La Vergne Planning Commission
May 26, 2026 at 6:00 PM

Planning Commission Report
Meeting: May 26, 2026

Item #: 3. **Site Plan - 1370 Heil Quaker Boulevard - Proposed Truck Parking on 2.51 Acres. Property located at 1370 Heil Quaker Blvd. (Tax Map 17, Parcel 28.01). ID (Interchange District) Zoning District. Property owned by Harsimranjeet Kaur. Requested by Huddleston Steele, Inc.**

OFFSITE SEWER PLAN

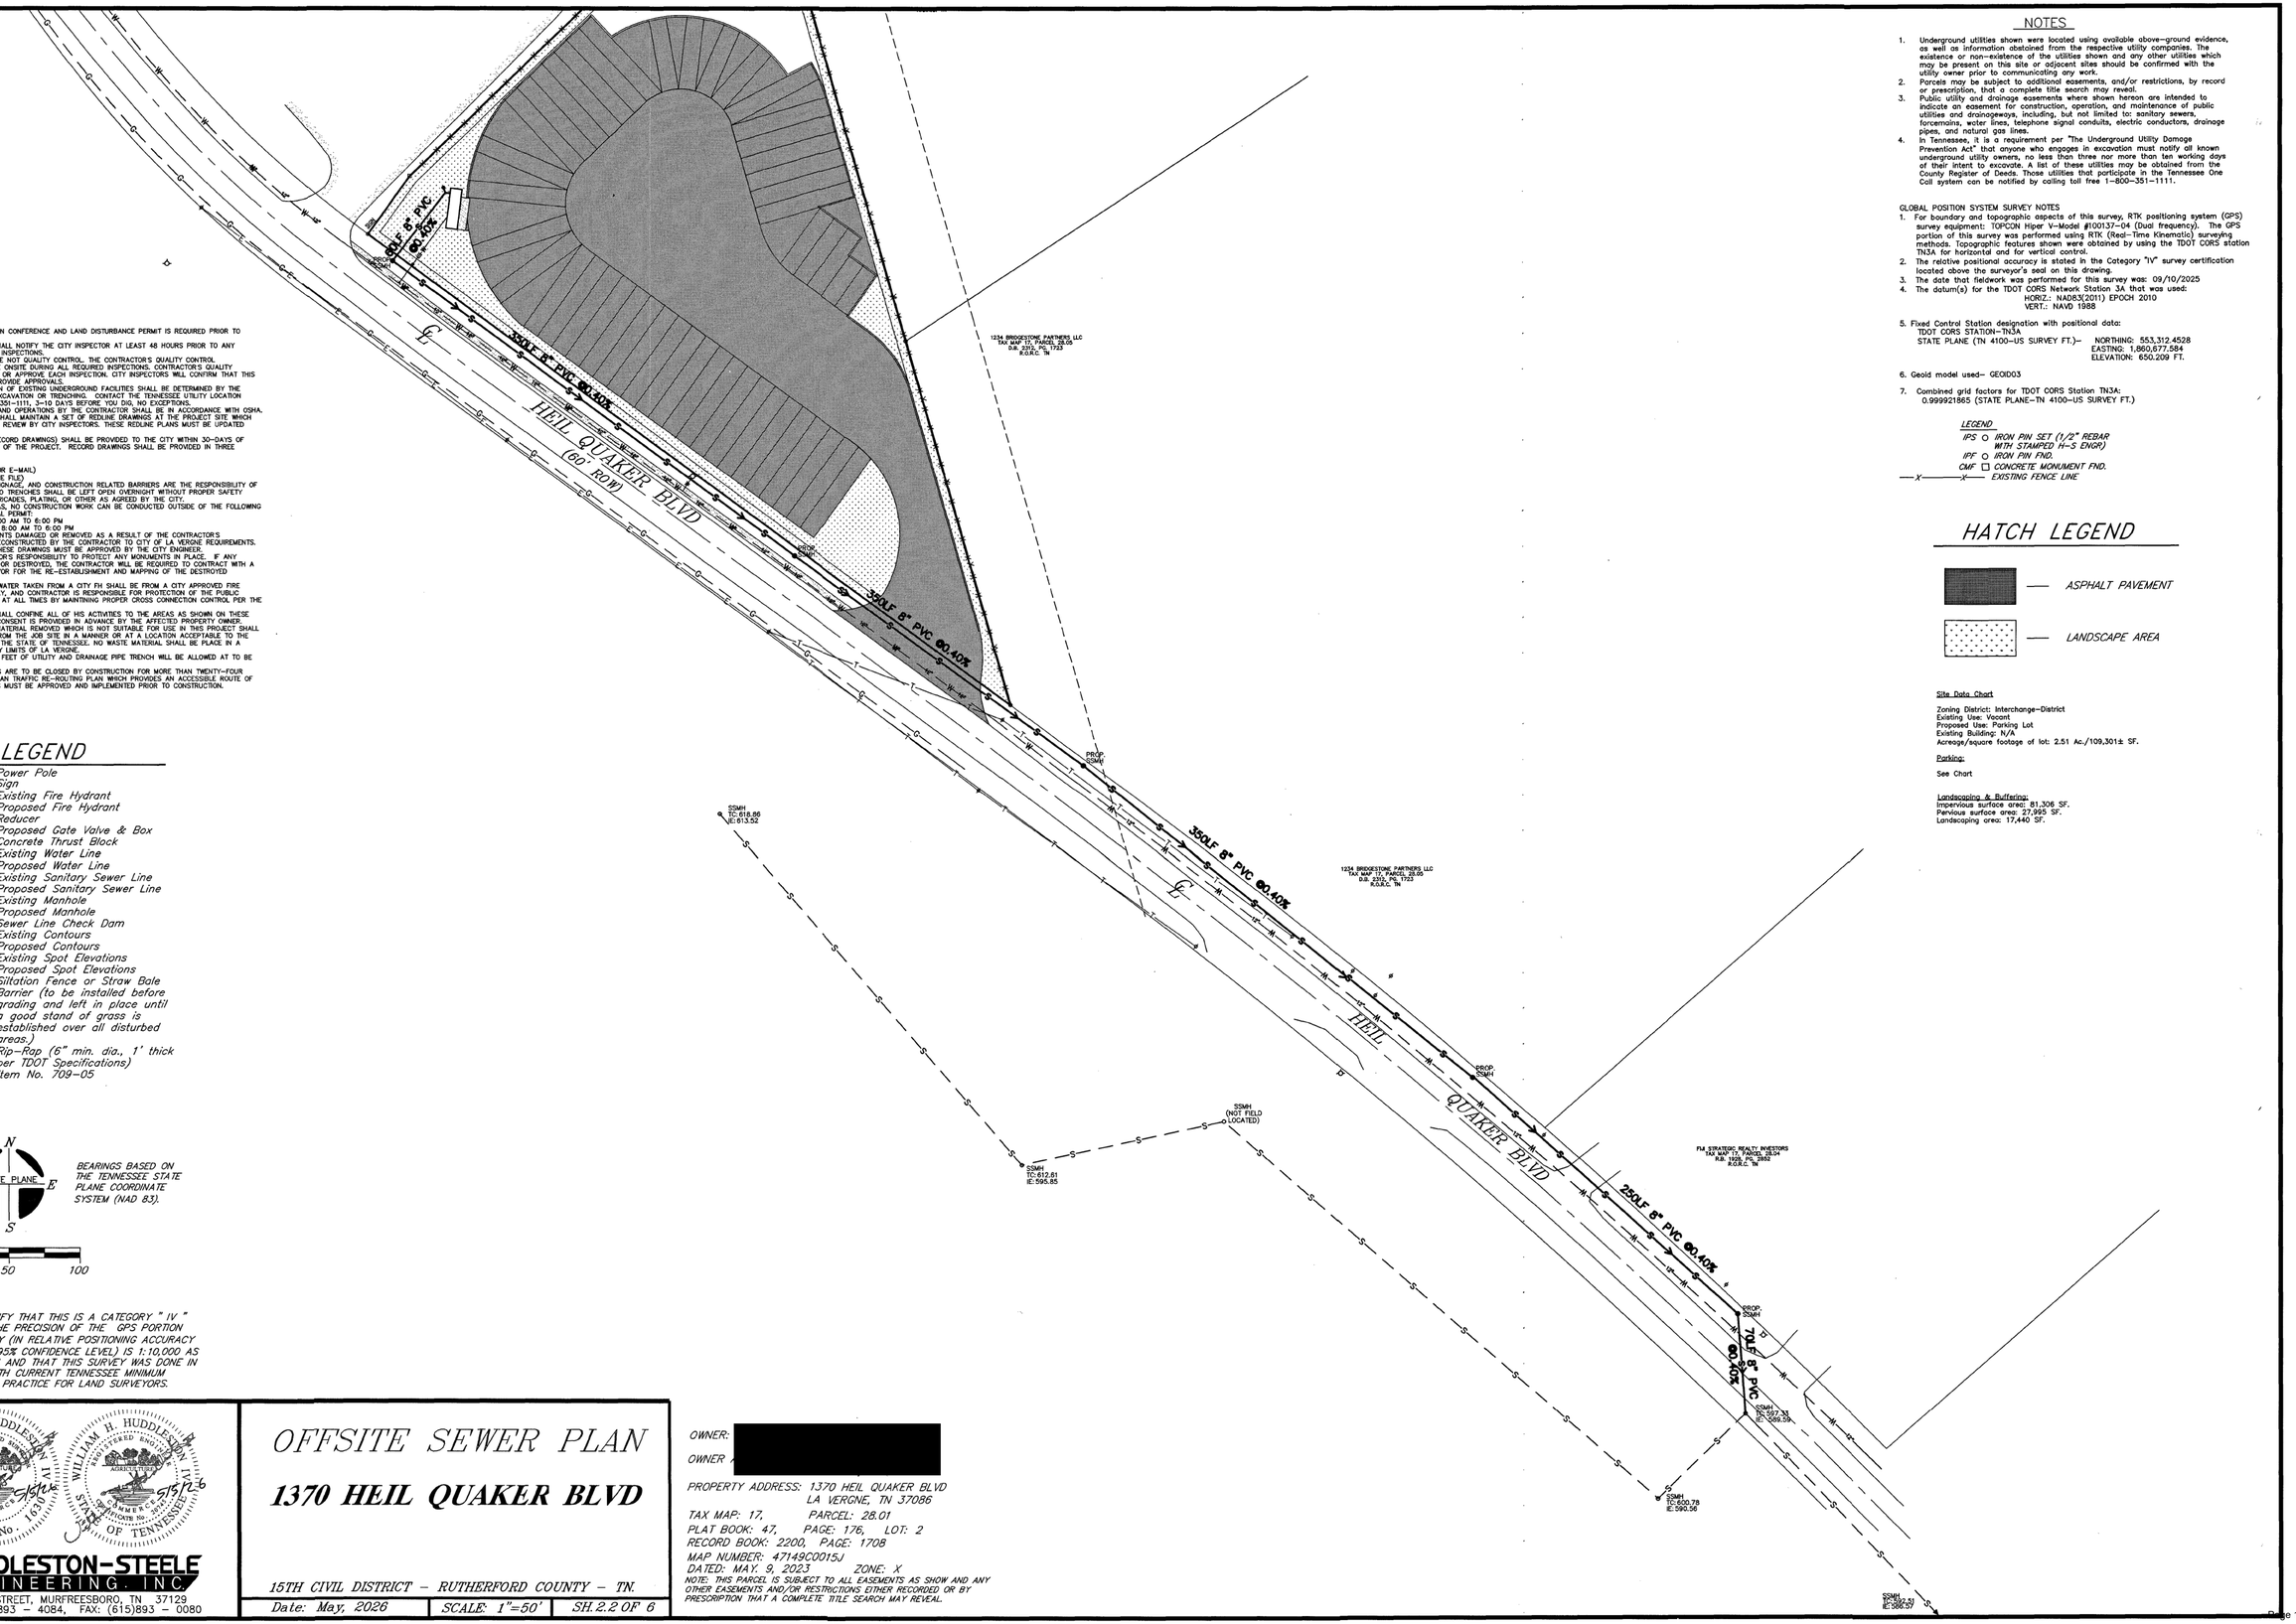
3. Show high pressure gas transmission line (Colonial) on the plans. Obtain information from gas company on existing gas line depth and diameter to determine if the sewer forcemain will cross over or under the gas.

SHEET NUMBER: C-2.0

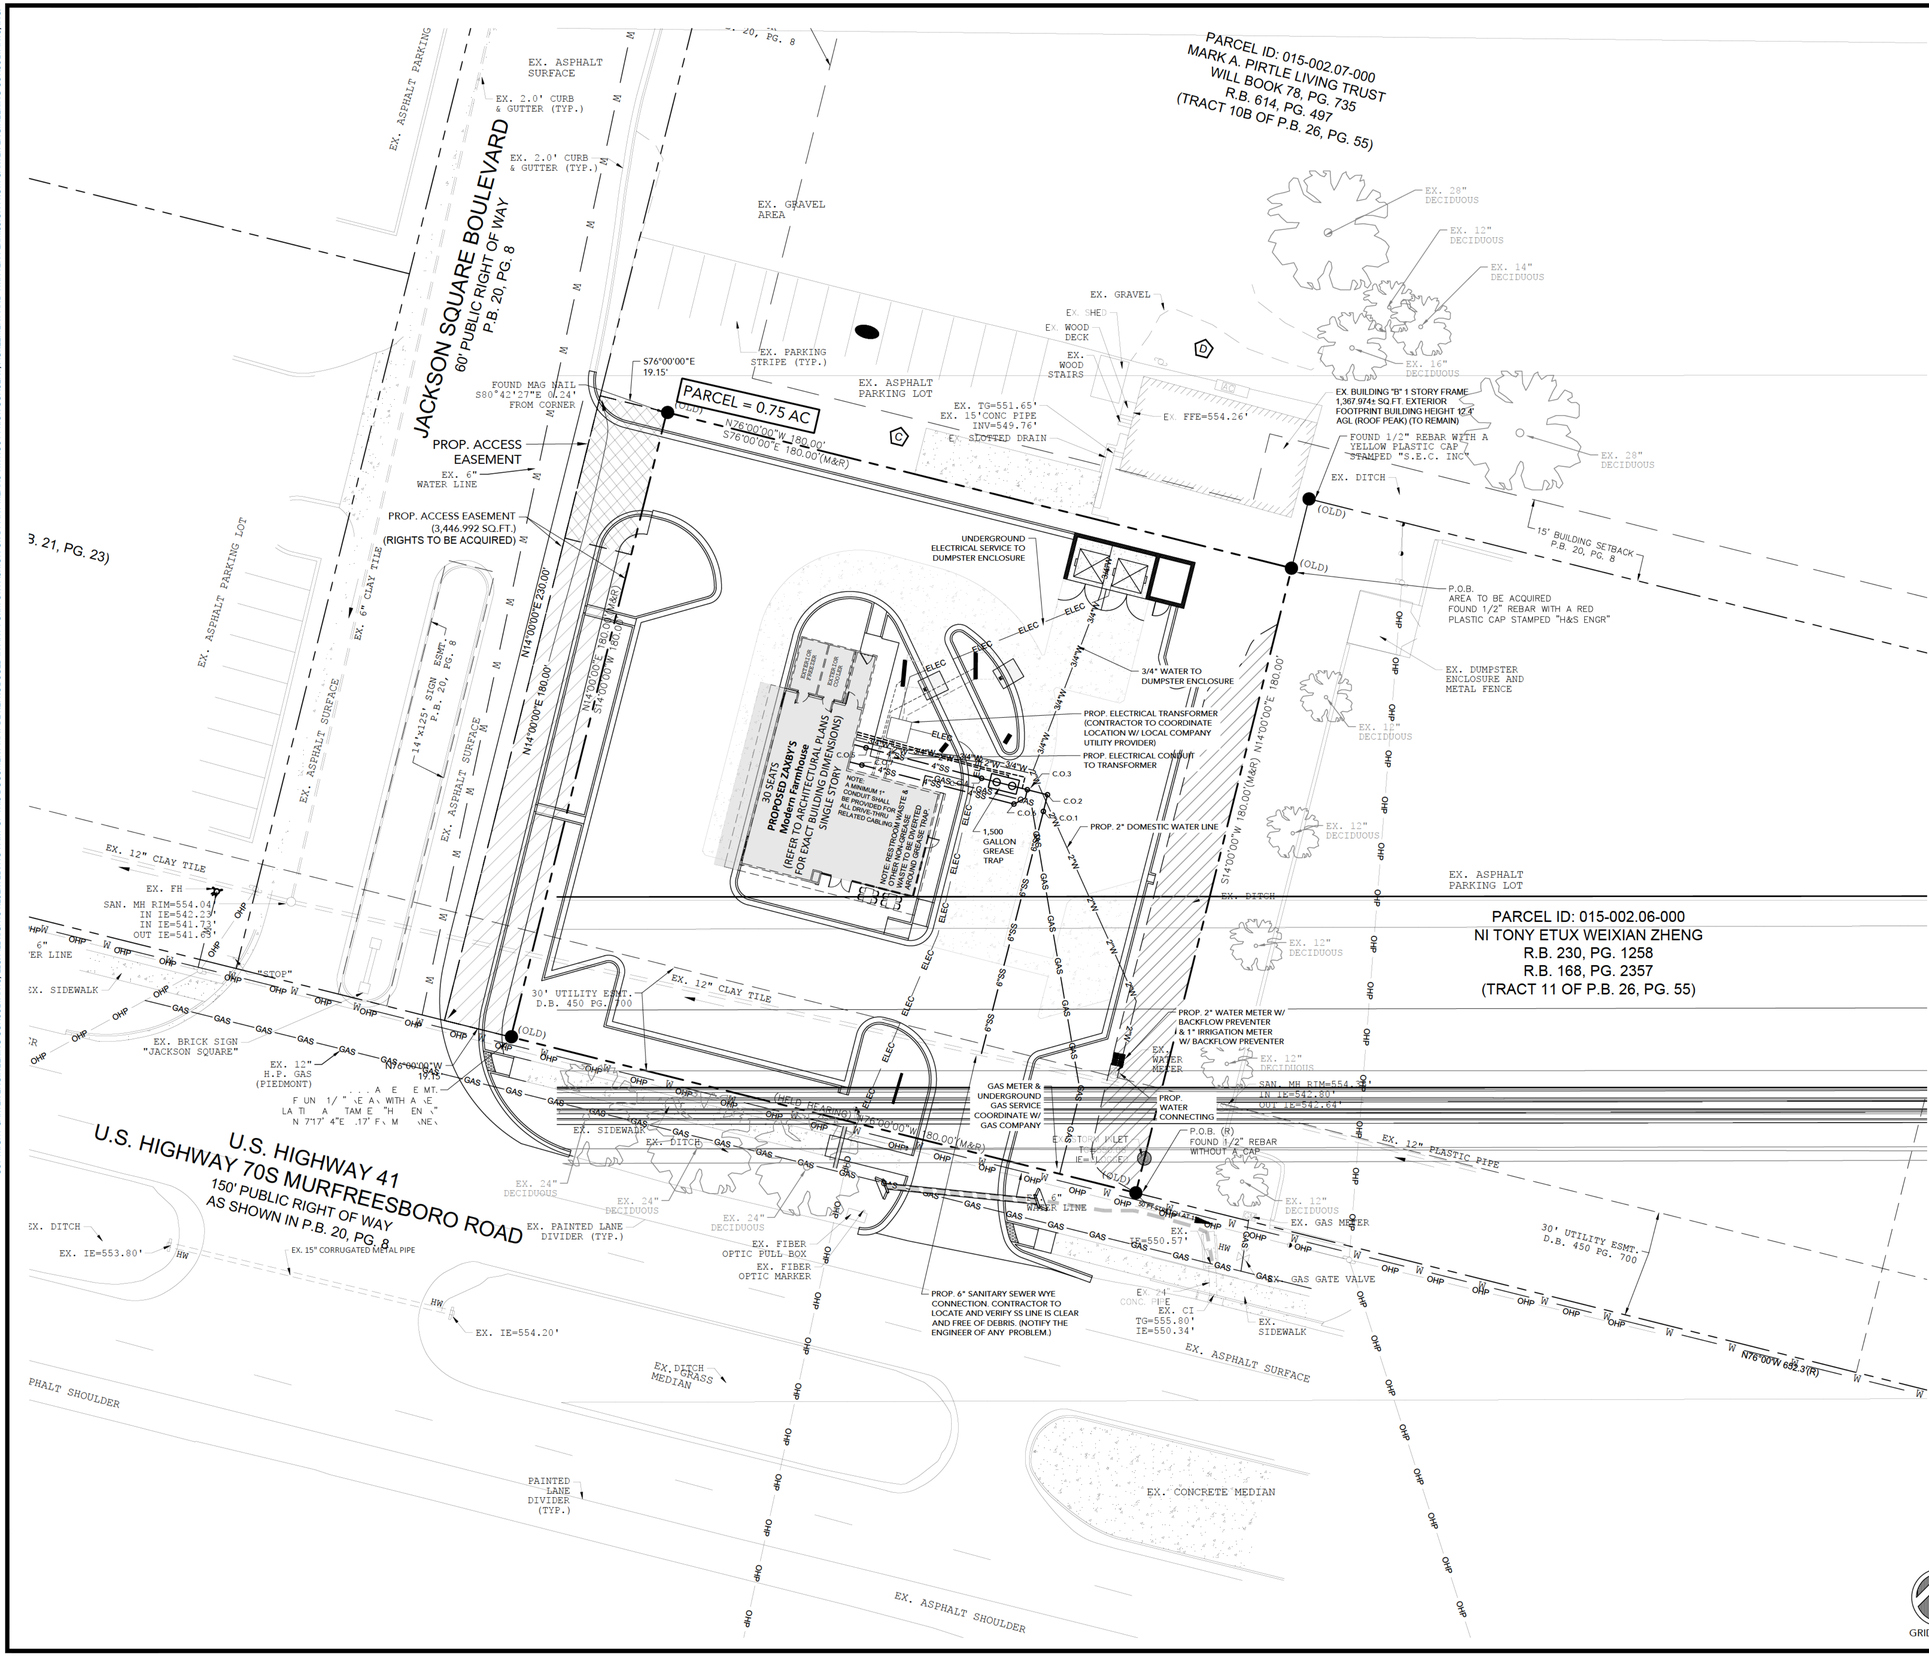
1. Setbacks are empty on Sheet C2.0.
2. Height is not shown.
3. The restaurant needs to submit full-color architectural elevations.
4. The required materials board was not submitted. Board must contain actual samples of all exterior materials.

16. (Sheet C-2.0) Radius return of drive onto Jackson Square Blvd cannot extend past the property boundary. A smaller radius return will be allowed in that location.

17. (Sheet C-2.0) Show distance of each driveway from the nearest property line.
18. (For information) A traffic study is not being required by staff due to the historical use of this property.

19. (Sheet C-2.0) Show width of striped area between the ADA spaces.
20. (Sheet C-2.0) Label which ADA spaces will be van accessible.
21. (Sheet C-2.0) Label angled parking as 60-degree.

22. (Sheet C-2.0) Most standards for travel aisles behind 60-degree parking are 18’. Justify why 14’ is sufficient in this case.
23. (Sheet C-2.0) While the monument/pole sign will be permitted through the Codes Department, provide the height, dimensions, and materials which will be used on that sign for review by the Planning Commission.

29. (Sheet C-2.0) Show elevation and materials for screen walls and gates around the dumpsters.

SHEET NUMBER:
C-4.0

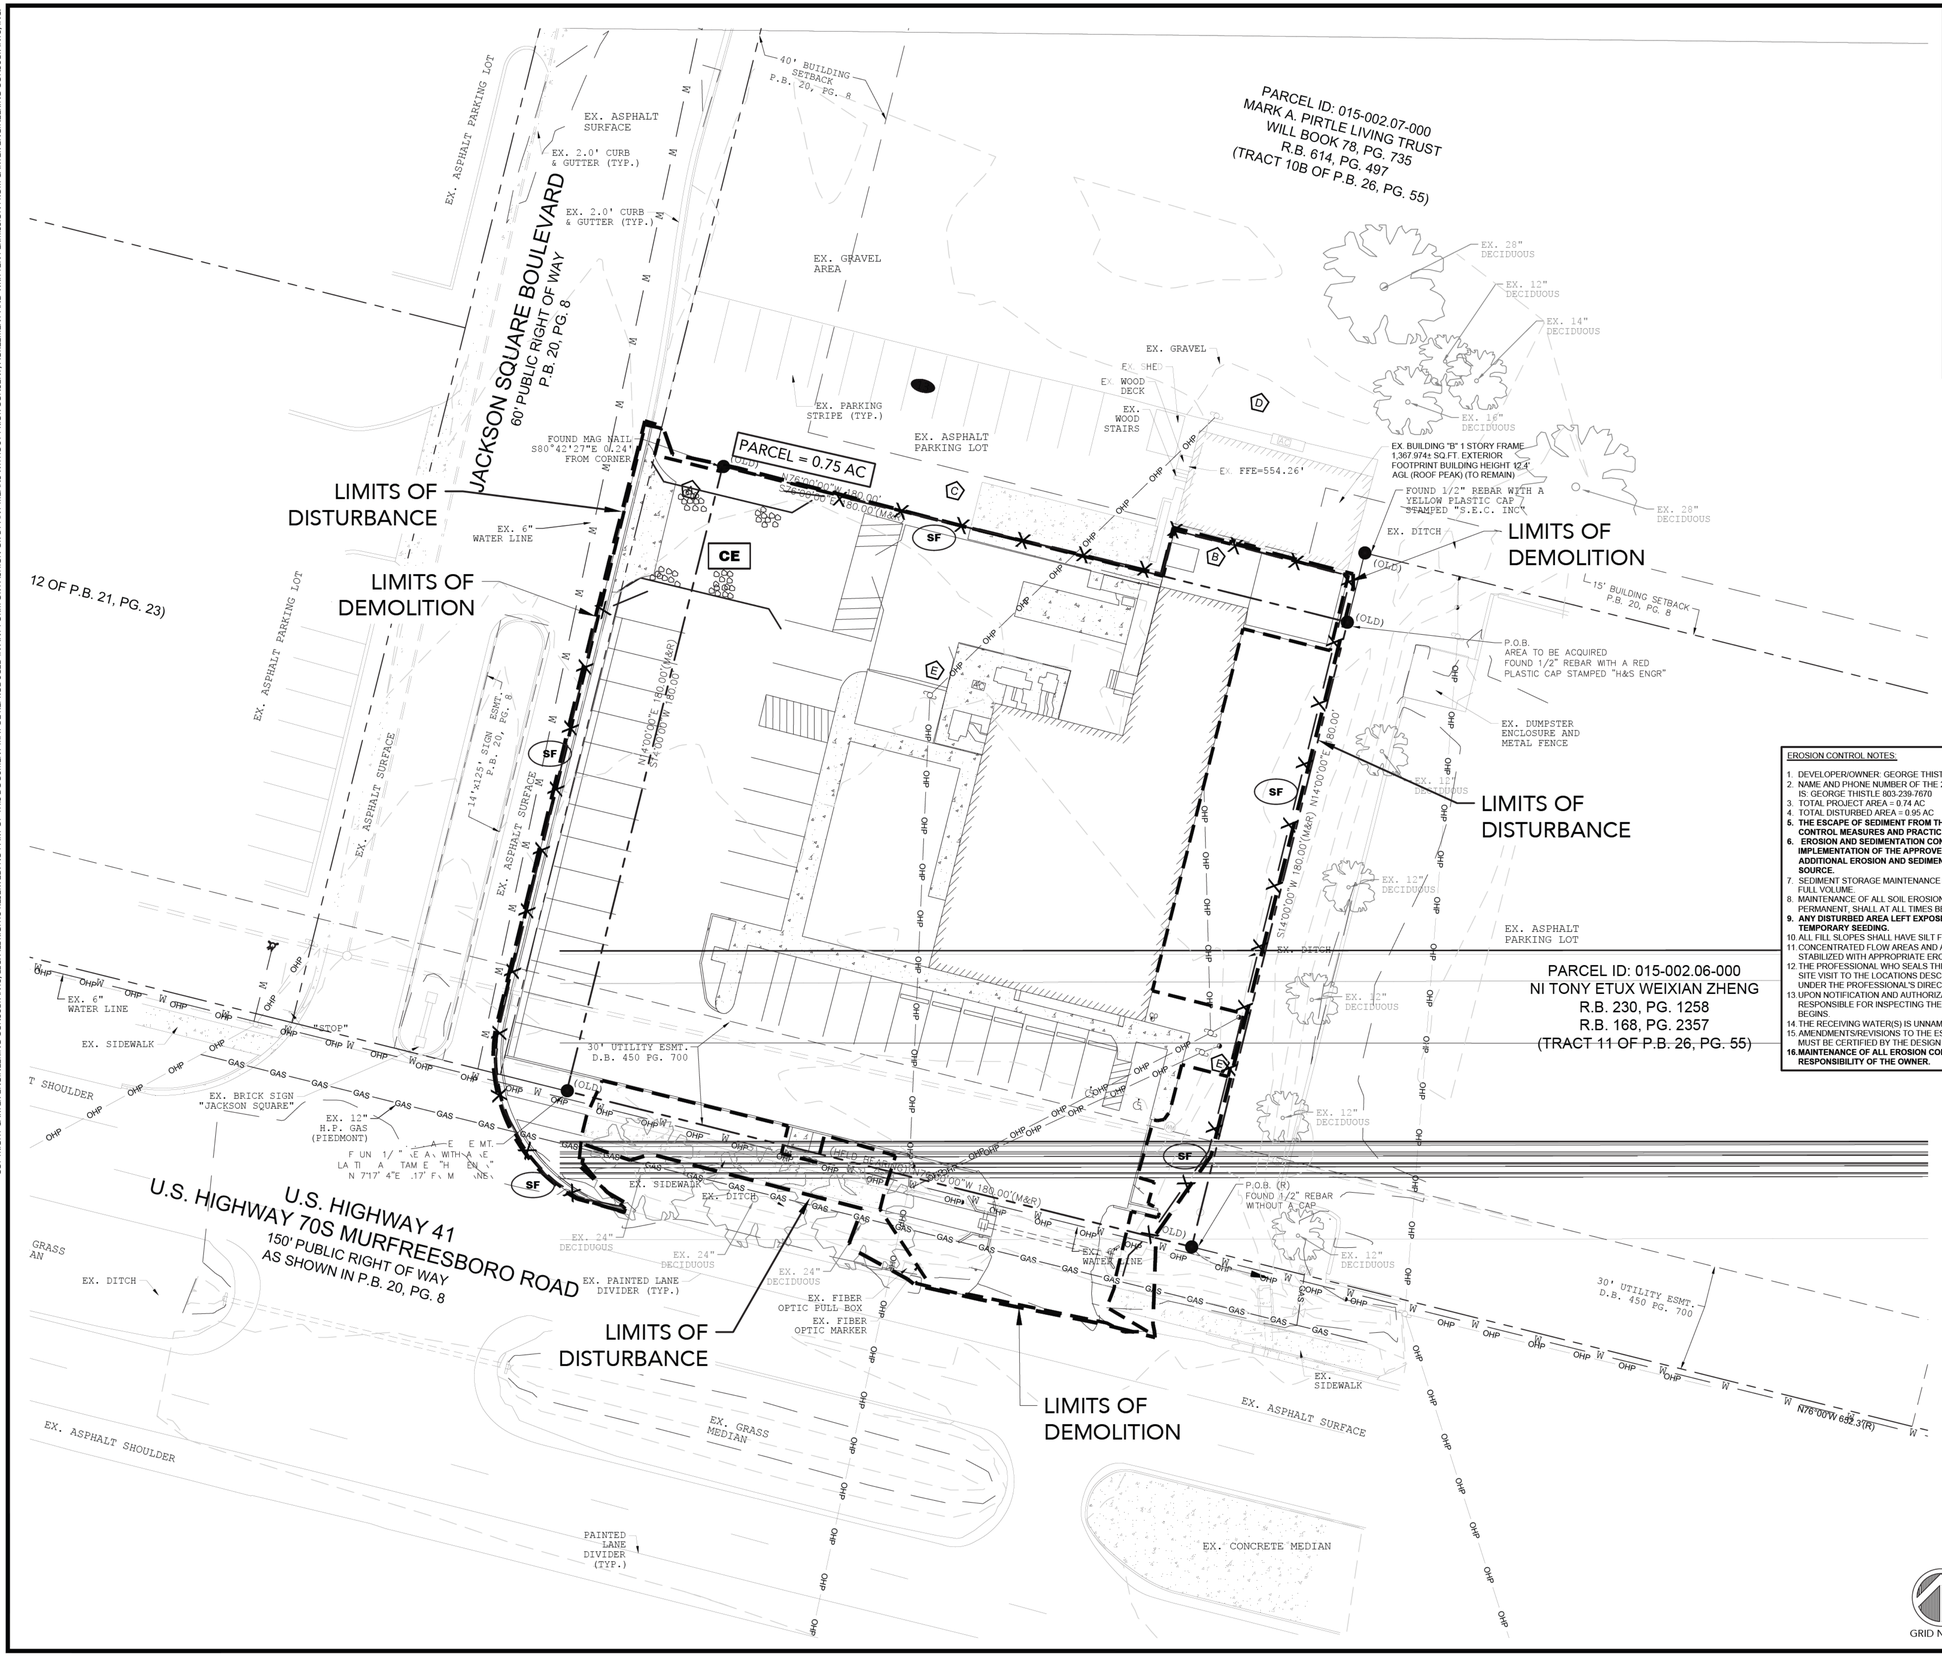
14. (Sheet C-5.0) Add City Standard Detail C013 for all public walks
15. (Sheet C-4.0) Wherever a flume outfalls onto grass, provide riprap or other form of energy dissipation.

24. (Sheet C-4.0) Provide calculations proving that the proposed 12” PVC drain pipe under the public sidewalk will be sufficient to pass the 25-year/24-hour storm without overtopping the walk.

25. (Sheet C-4.0)) Provide calculations proving that the proposed 15” RCP drain pipe under the drive from Murfreesboro Road will be sufficient to pass the 25-year/24-hour storm. This is in addition to any TDOT requirements.

26. (Sheet C-4.0) Call out the ‘OP’ detail from Sheet C-5.0 for the 15” RCP under the drive from Murfreesboro Road.
27. (Sheet C-5.0) Show the temporary construction entrance detail. The city standard is that the travel entrance must be a minimum of 100-feet long. On sites such as this one, engineer may present an alternative such as a pressure washing station at the construction entrance if the 100-foot requirement cannot be met.
